Name of Facility: Union Pacific Railroad Company

This letter is the Decision of the Director of Water Resources to grant Permit to Withdraw Poor Quality Groundwater No. 59-212083.0000 to Union Pacific Railroad Company.

This letter, with attachments, is intended to provide the additional information requested by the ADWR. The information requested by the ADWR on 25 May 2006 is listed below in italics followed by a brief description of the information provided to address ADWR's request.

**TO:** Jeff Tannler  
Linda Ingraham  
Tucson AMA  
**FROM:** David Christiana, Supervisor *DC*  
Technical Support Unit  
**DATE:** May 22, 2006  
**SUBJECT:** Poor Quality Groundwater Withdrawal Permit – Union Pacific Railroad, Tucson

Figure E-2  
 Horizontal Boring Well Construction Plan  
 Passenger Depot Site  
 Union Pacific Railroad Company  
 Tucson, Arizona

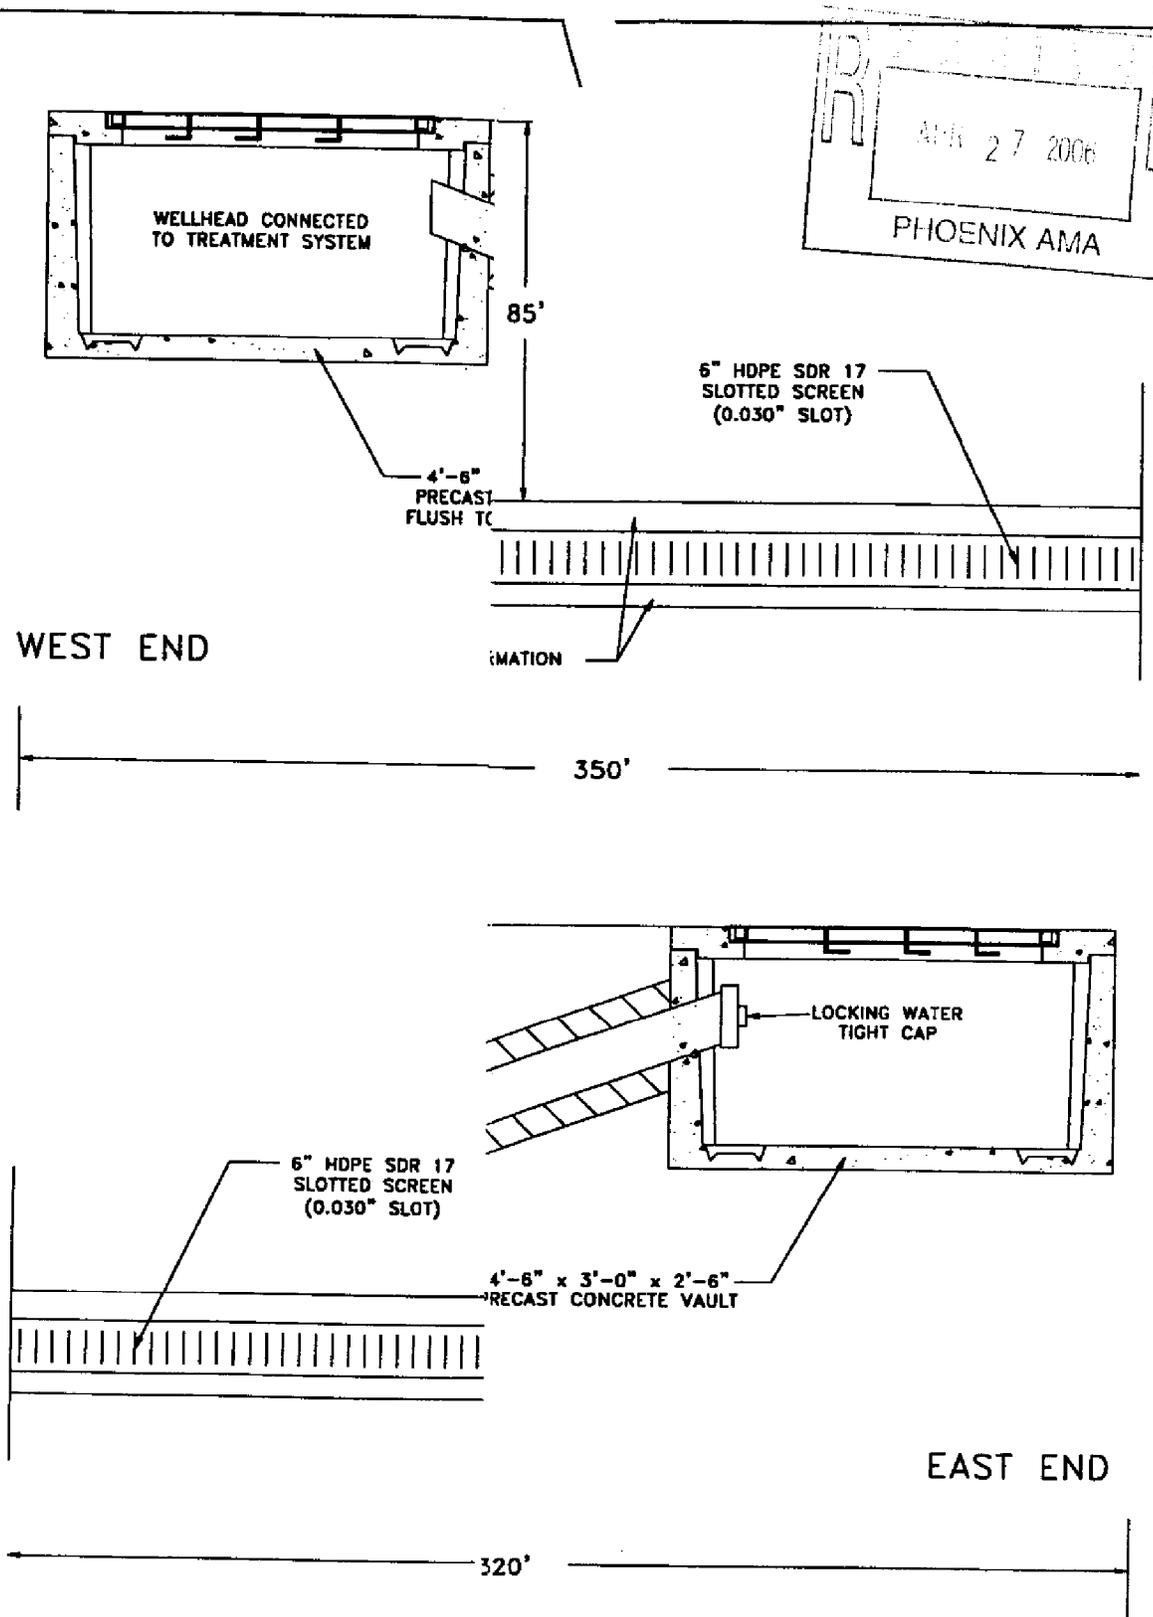
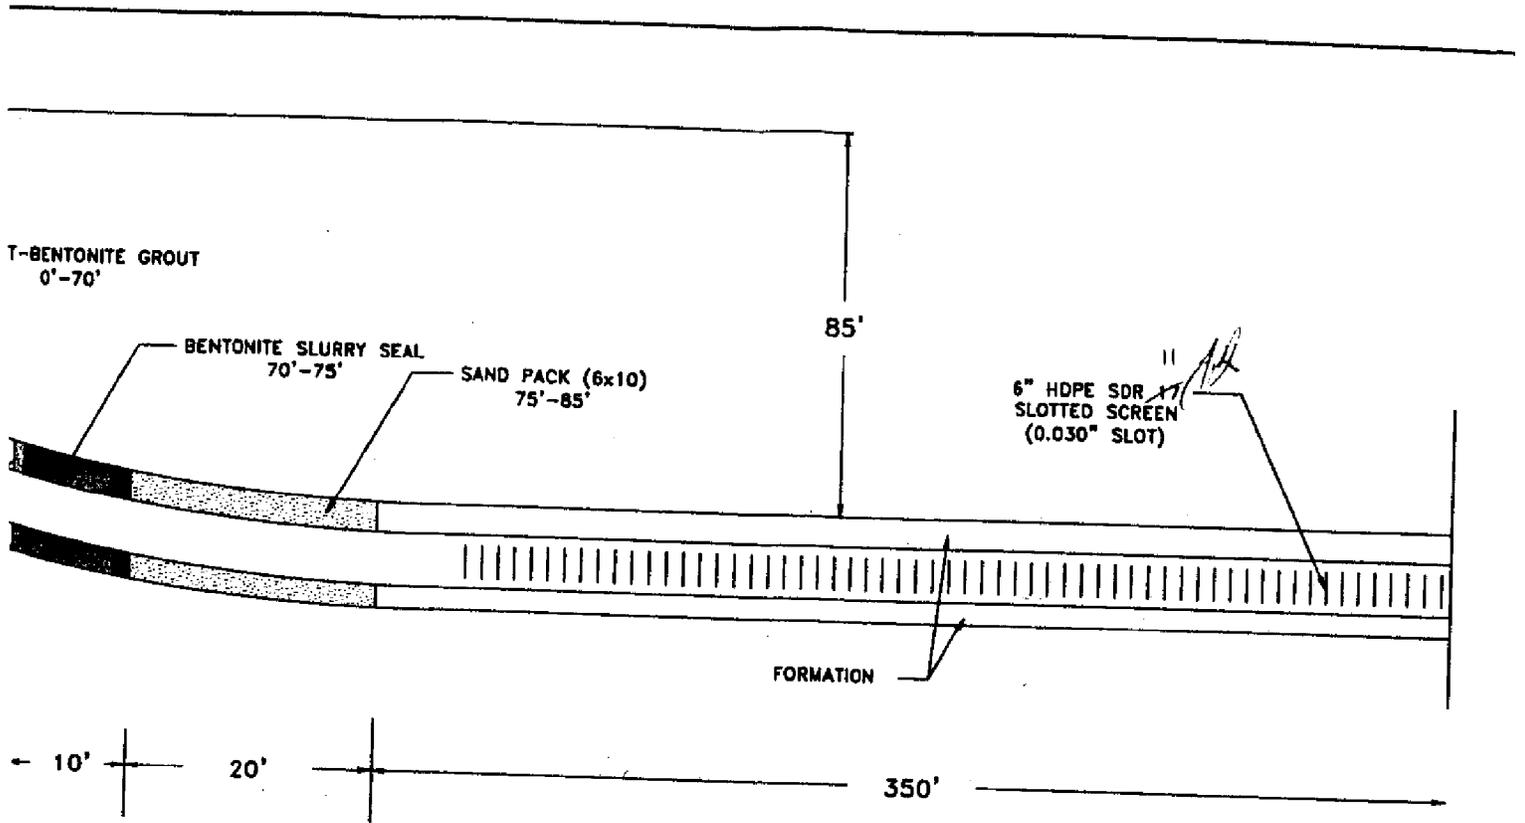
1. *"In accordance with A.A.C.R12-15-811.B.4, all horizontal wells, to prevent leakage, shall be constructed with a surface seal consisting of steel casing and cement grout extending a minimum of ten feet into the land surface. Figure E-2 submitted with the application shows HDPE riser pipe in the upper 20 feet of the wall."*

1. In accordance with A.A.C. R12-15-811.B.4, all horizontal wells, to prevent leakage, shall be constructed with a surface seal consisting of steel casing and cement grout extending a minimum of ten feet into the land surface. Figure E-2 submitted with the application shows HDPE riser pipe in the upper 20 feet of the well.

1. A letter requesting a variance from minimum well construction standards is required for the construction of the horizontal well, ADWR registration #55-212084. Figure E-2 shows HDPE riser pipe in the upper 20 feet of the well. Minimum construction standards specify steel casing. The variance request must describe the variance, why the variance is necessary, and explain how the construction will be protective of the aquifer.

As allowed by A.A.C. R12-15-820, ERM requested a variance for use of thermoplastic casing surface seal in lieu of steel casing and cement grout. A copy of the variance request with all additional required information is provided in Attachment A.

Because there are elbowed transitions between the horizontal plane and riser portions of the well, the well material must be flexible to facilitate construction. As such, UPRR seeks the use of HDPE casing in lieu of steel for the upper ten feet of the well. The ends of the horizontal well will terminate in traffic-rated, tamper-resistant, water tight concrete vaults at the ground surface and annular space from the concrete vaults to a depth of approximately 70 feet below ground surface will filled (via tremmie pipe) with cement-bentonite grout to prevent leakage.

Because there are elbowed transitions between the horizontal plane and riser portions of the well, the well material must be flexible to facilitate construction. As such, UPRR seeks the use of HDPE casing in lieu of steel for the upper ten feet of the well. The ends of the horizontal well will terminate in traffic-rated, tamper-resistant, water tight concrete vaults at the ground surface and annular space from the concrete vaults to a depth of approximately 70 feet below ground surface will filled (via tremmie pipe) with cement-bentonite grout to prevent leakage.
